MEADOWBROOK PARK

CIVIL CONSTRUCTION DOCUMENTS

PCD FILING NO. SF-21-025

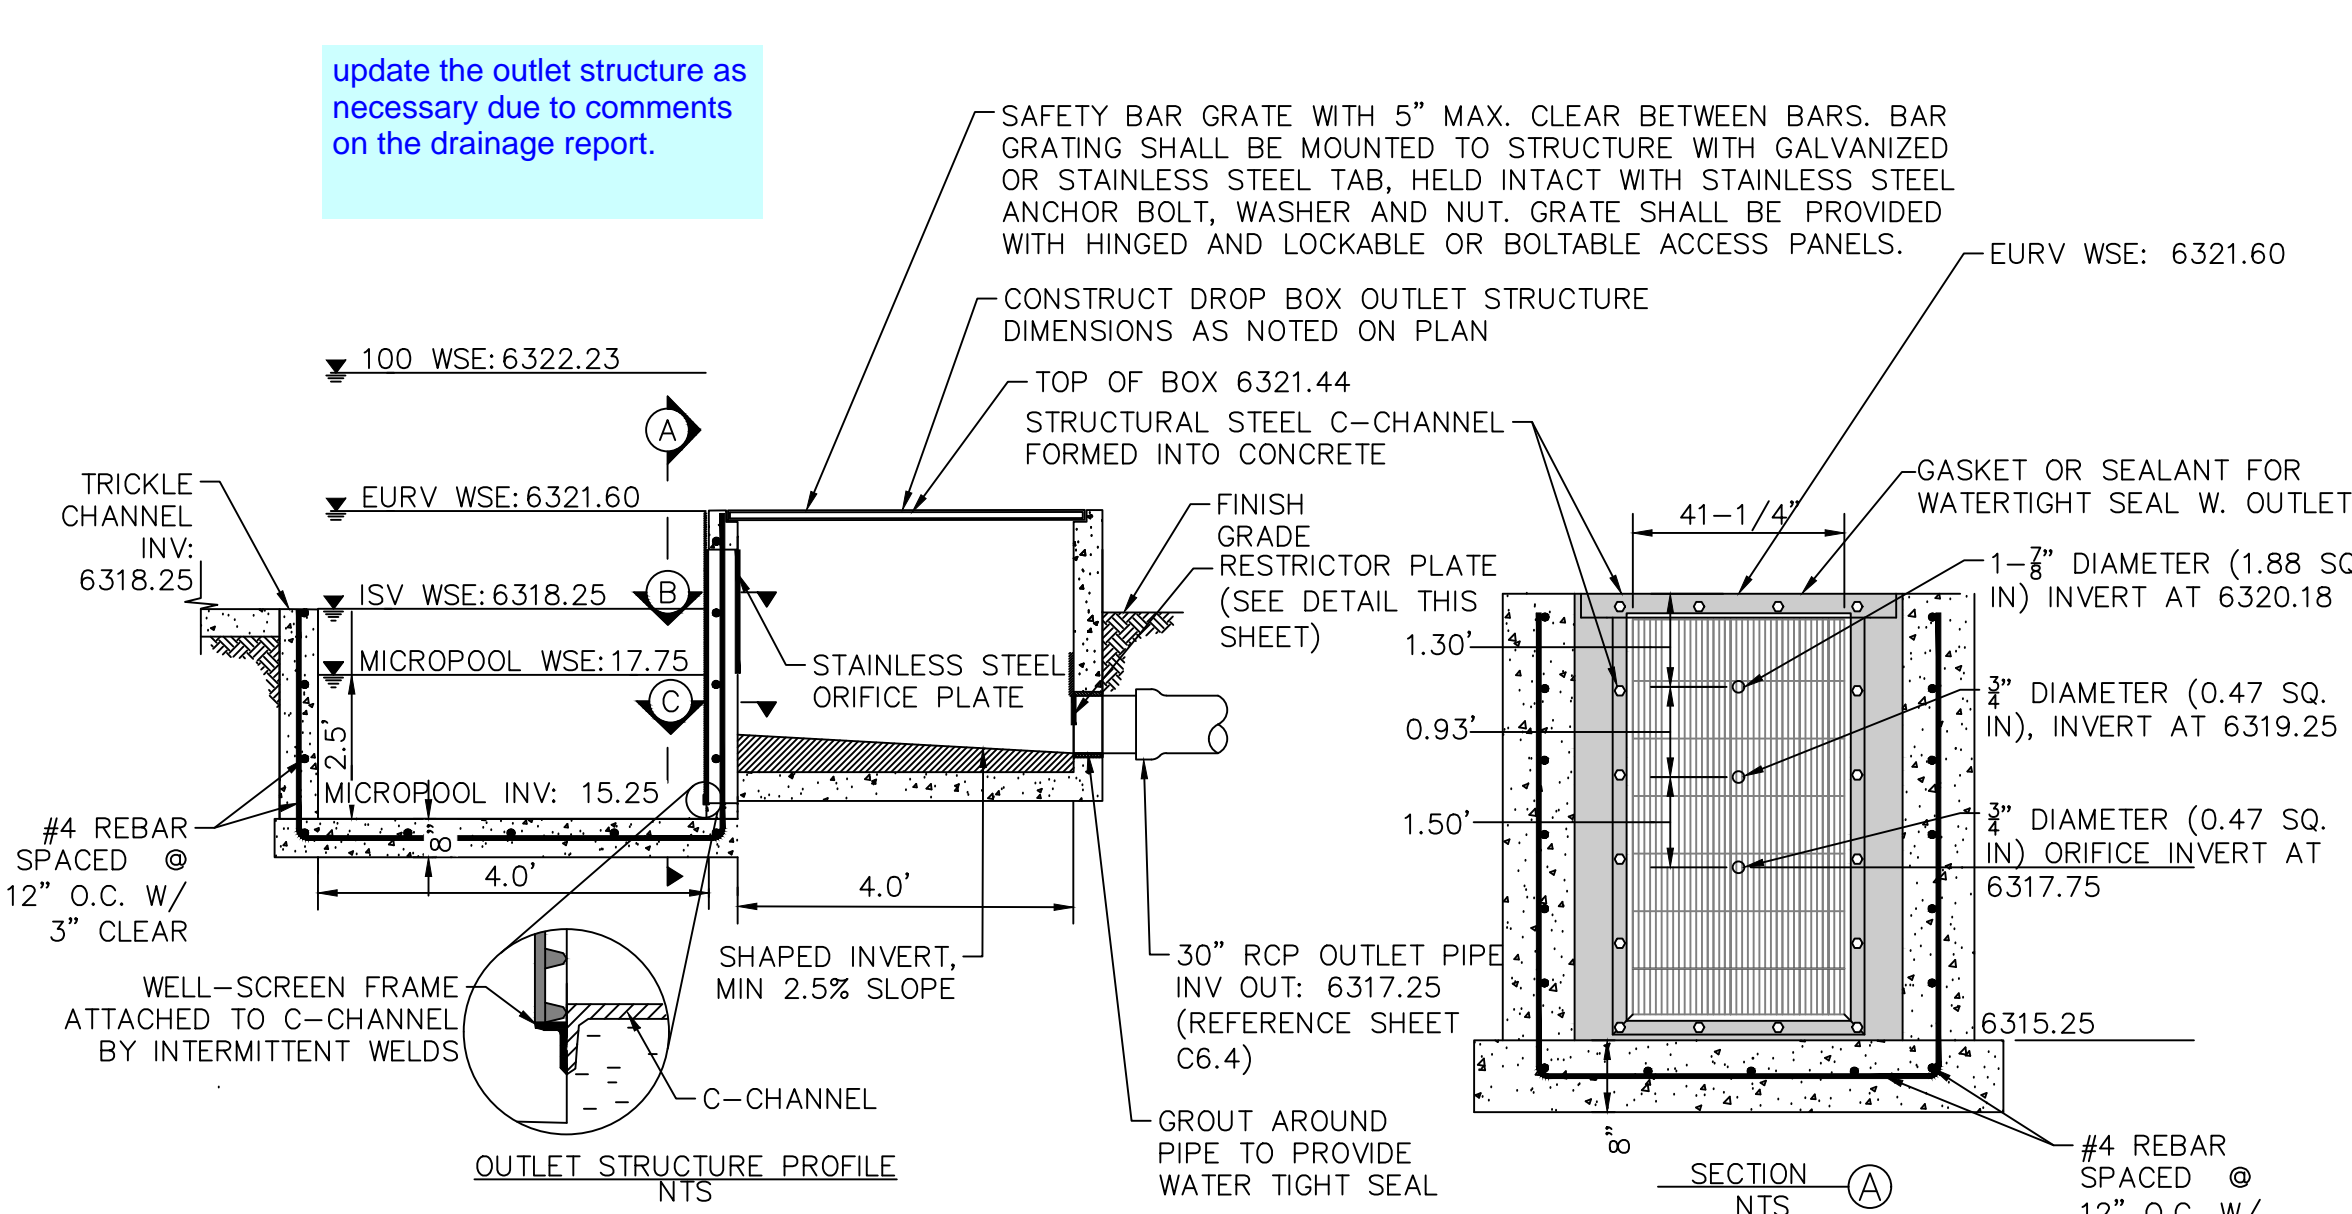
PROPOSED FULL SPECTRUM DETENTION BASIN
 The drainage plan indicates D50=12in which would be a type M. revise accordingly.
